# ADDENDUM #2

February 4, 2026
CGMH NEW NUCLEAR MEDICINE SPECT/CT SUITE RENOVATION PROJECT
Job Number: 24-200
To: All Bidders, All Consultants, Project Manager
Number of Pages : 44

1 E301 POWER & SYSTEM - DEMO WORK
SCALE: 1/4" = 1'-0"

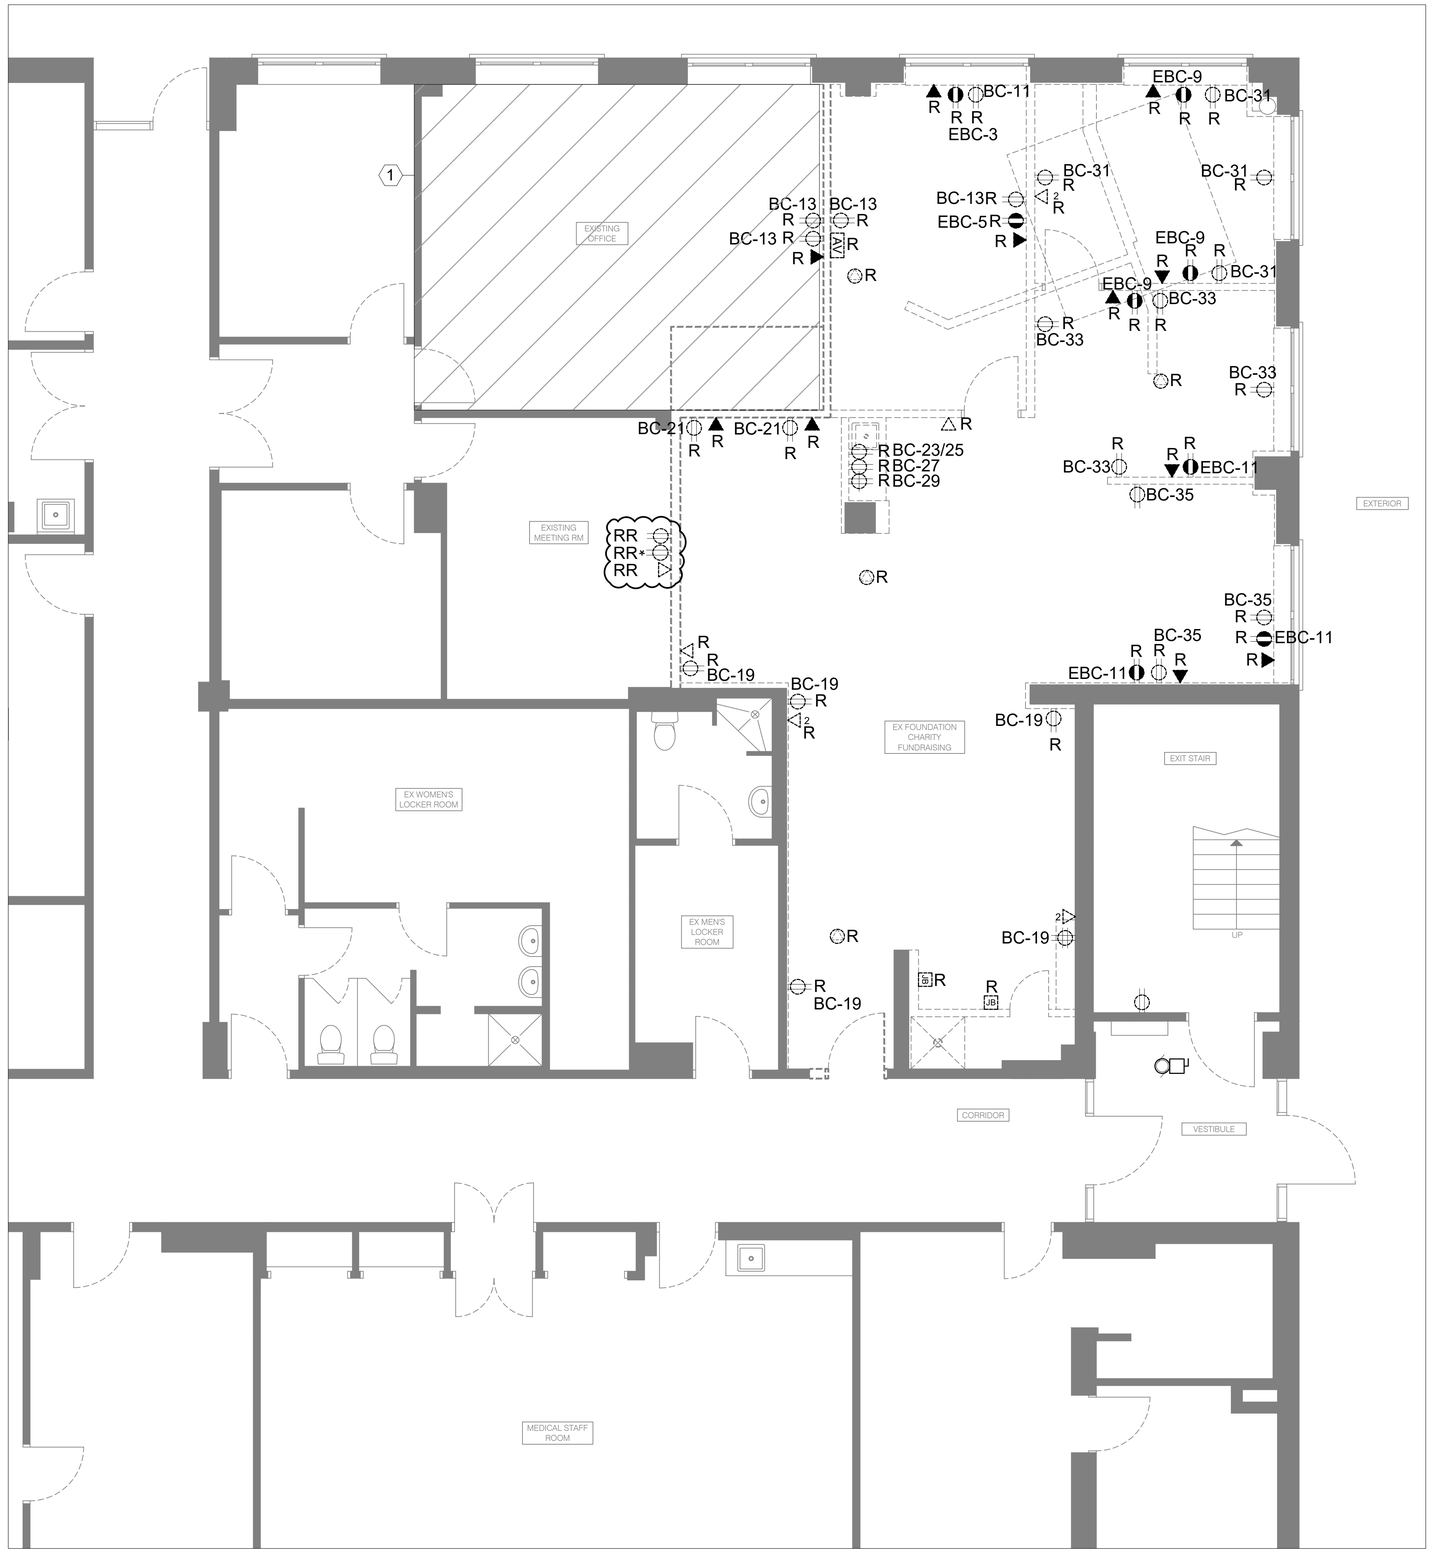
- Specified lighting fixture type: L3.
5. **Drawing E-301 – POWER & SYSTEM - DEMO**
   - Included 1 receptacle, 1 emergency receptacle, and 1 data receptacle to be RR.

2 E302 POWER & SYSTEM - NEW WORK
SCALE: 1/4" = 1'-0"

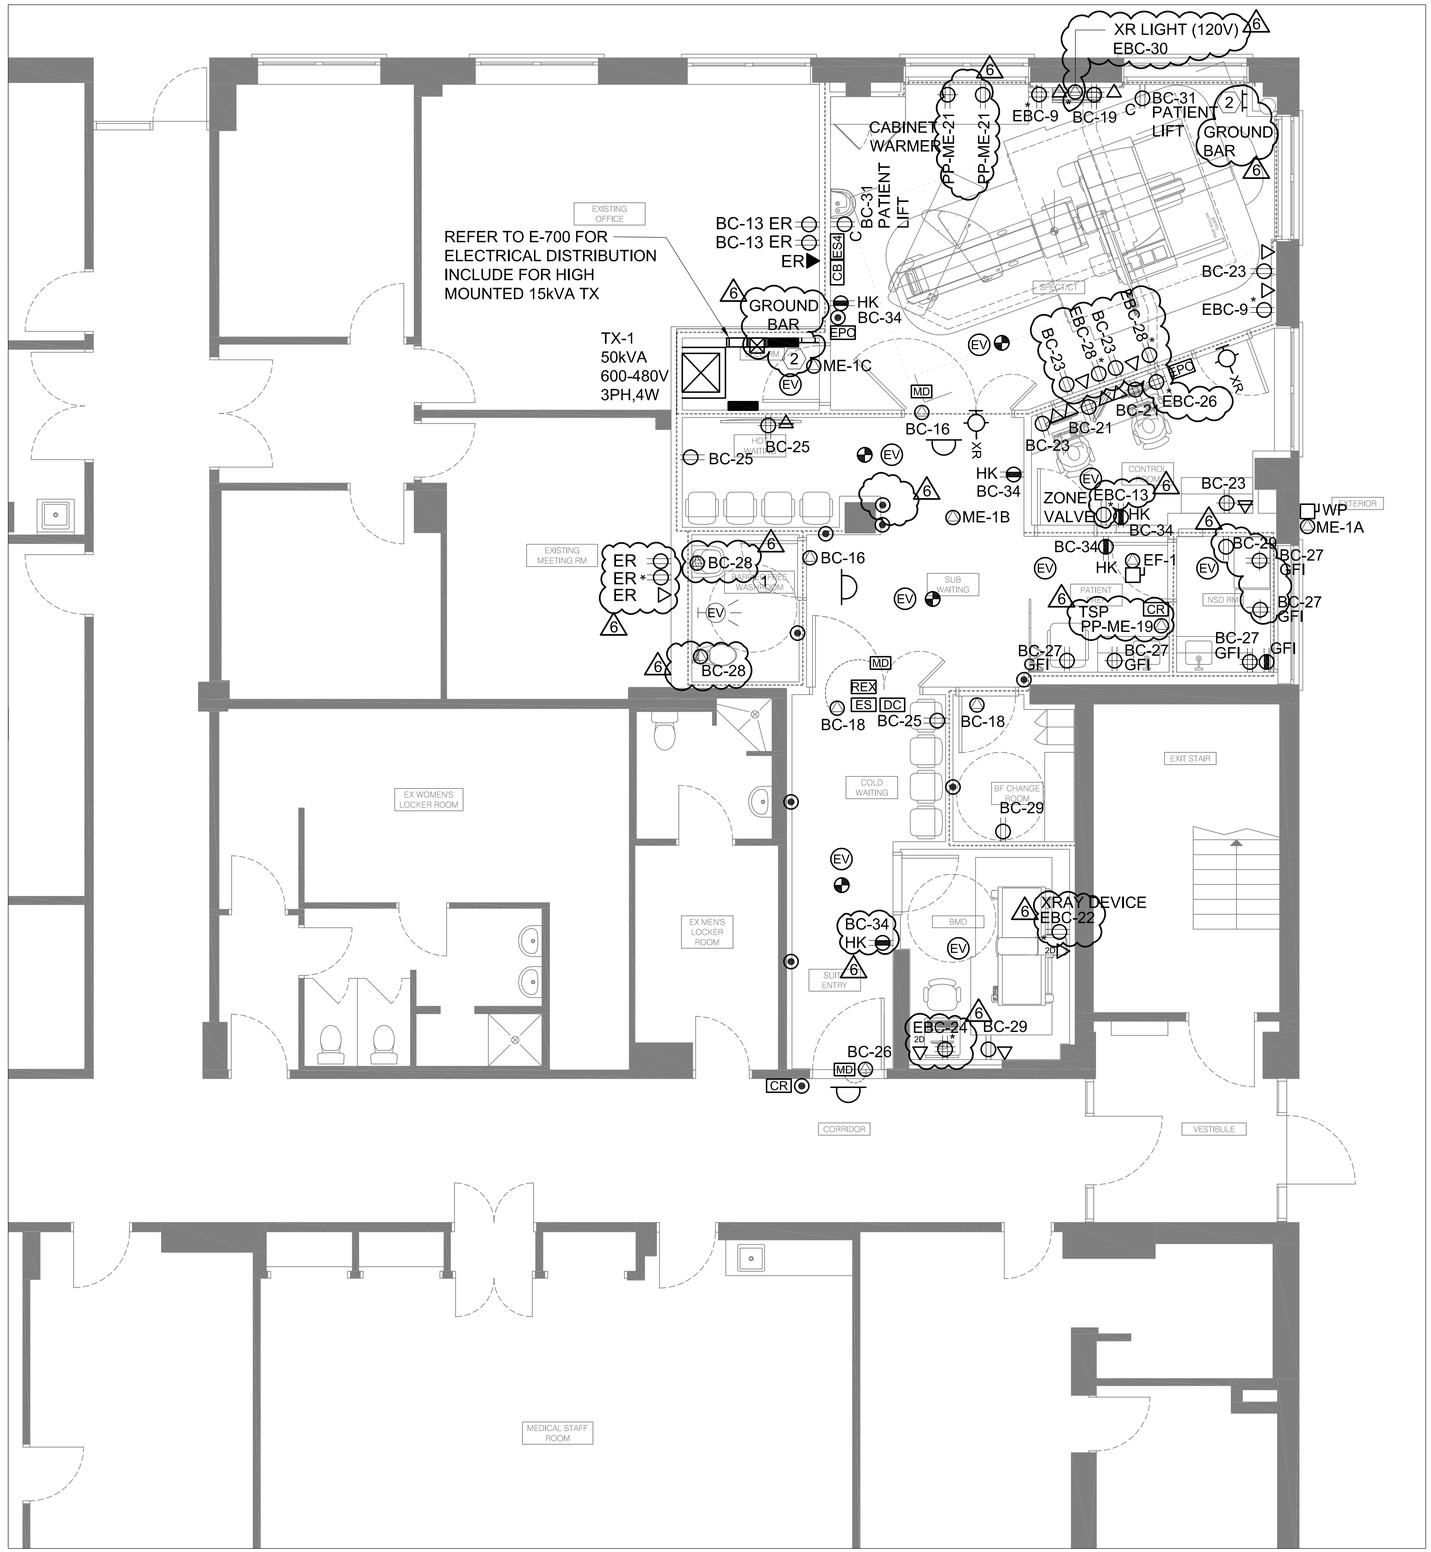
6. **Drawing E-302 – POWER & SYSTEM - NEW**
   - Included 1 receptacle, 1 emergency receptacle, and 1 data receptacle to be ER.
   - Added a ground bar to Electrical Room.
